REMARKS

Serial No.: 09/686,031
Conf. No.: 5932

Docket No. S1022.80549US00
Date: July 14, 2004
x07/14/04

Fig 4

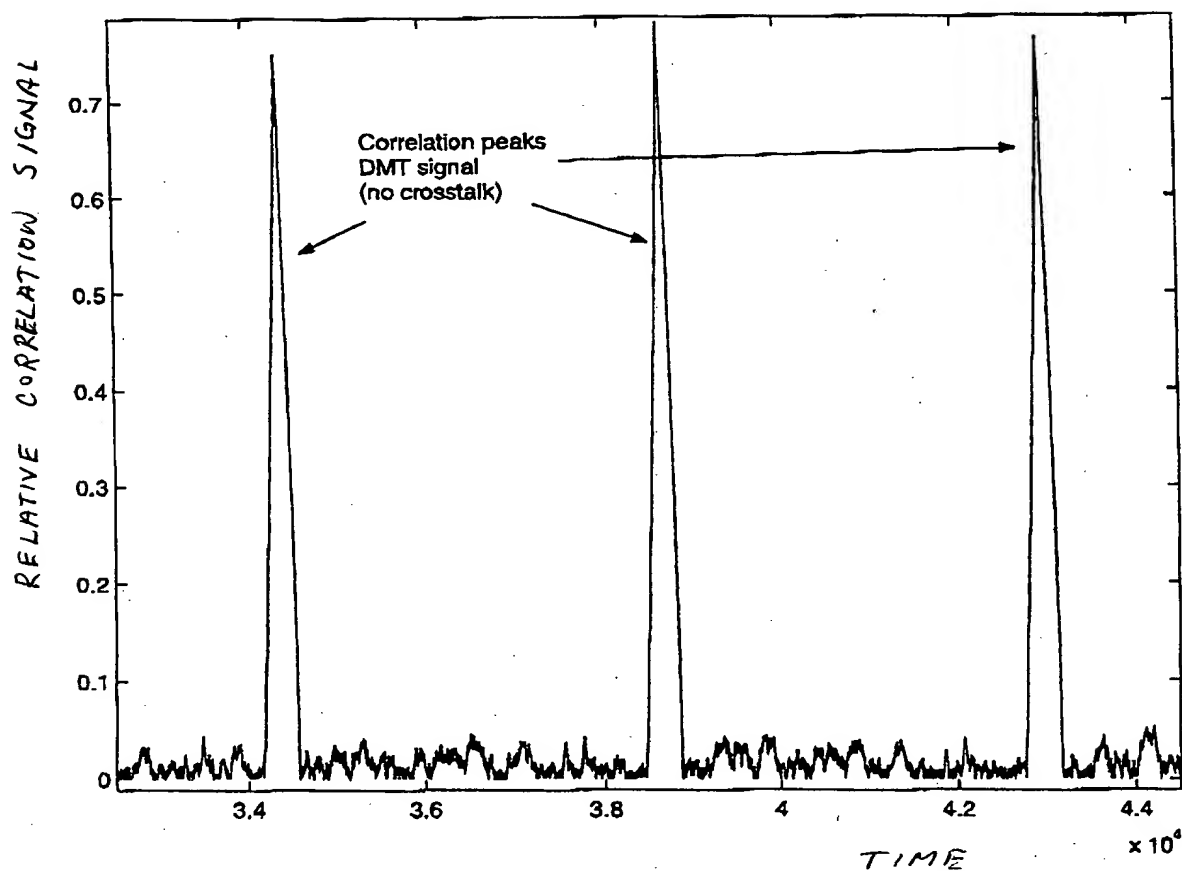
The Examiner has objected to the drawings and has suggested that units of the x and y axes be added to Figs. 4 and 5. Enclosed herewith are photocopies of Figs. 4 and 5 with proposed changes marked in red. Approval of the proposed drawing corrections is respectfully requested.

Annotated Sheet Showing Changes
